DOCKET NO. 50-266
POINT BEACH NUCLEAR PLANT, UNIT 1
STEAM GENERATOR REPLACEMENT

Enclosure 1 to this letter provides responses to requests for further technical and economic information related to replacement of the steam generators in Point Beach Nuclear Plant, Unit 1, which were formally transmitted by your letter of July 6, 1983. These requests were discussed during a meeting with Messrs. Colburn, Fields, and Toalston in our offices on June 23, 1983.

WISCONSIN ELECTRIC POWER COMPANY RESPONSE
TO NRC STAFF REQUEST FOR ADDITIONAL INFORMATION
POINT BEACH UNIT 1 STEAM GENERATOR REPLACEMENT

POINT BEACH STEAM GENERATOR REPLACEMENT
RETIRE POINT BEACH UNIT 1 EARLY (1/84)
DIFFERENCE IN
DISCOUNTED ACCUMULATED REVENUE REQUIREMENTS

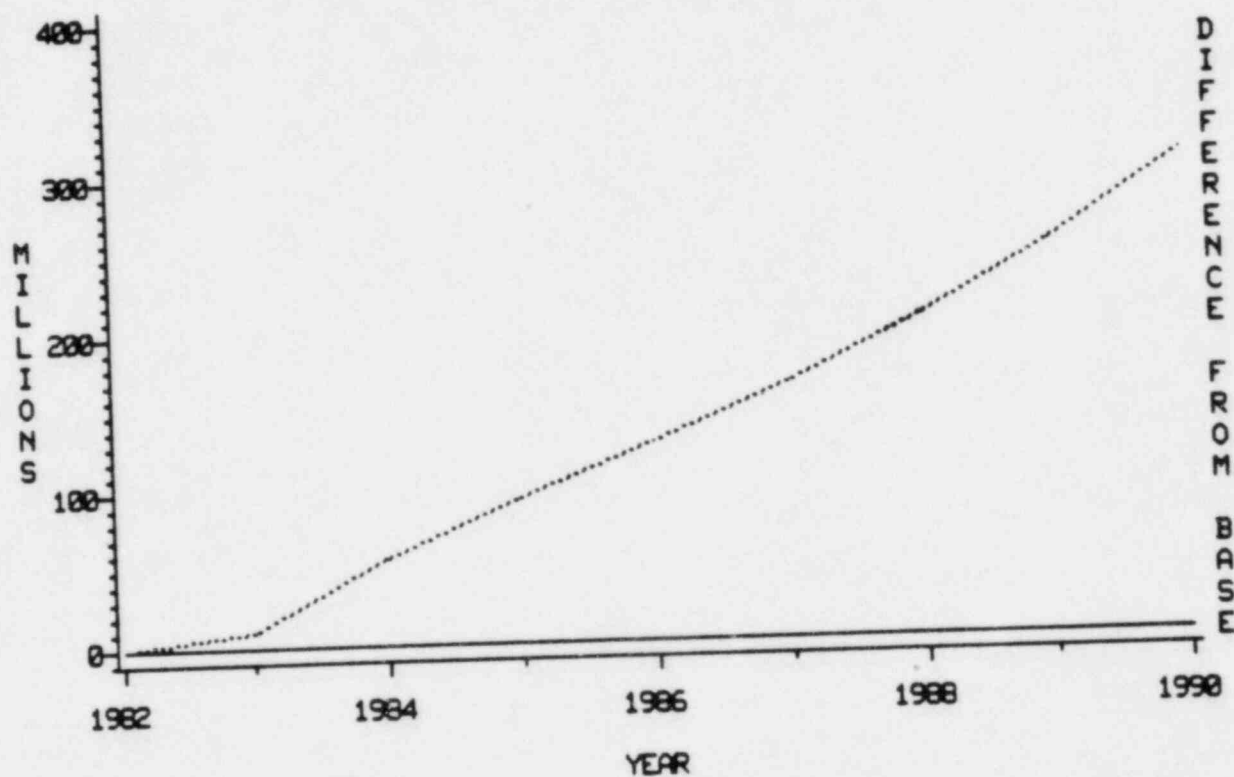
The option of shutting Unit 1 down and replacing the power by alternative generation with decommissioning to be conducted in the future in conjunction with Unit 2 was also analyzed at the request of the NRC staff. The same production cost model was used to compare the replacement option with operating Unit 1 at reduced power for the Public Service Commission of Wisconsin. The results of this analysis indicate estimated costs in the order of \$306 million through the year 1990 for the decommissioning alternative. This analysis is provided as Attachment 2 to this enclosure.

—— CASE 1 - PRESENT OPERATION - NO STEAM GENERATOR REPLACEMENT (BASE CASE)

..... CASE 2 - RETIRE POINT BEACH UNIT 1 (1/84)
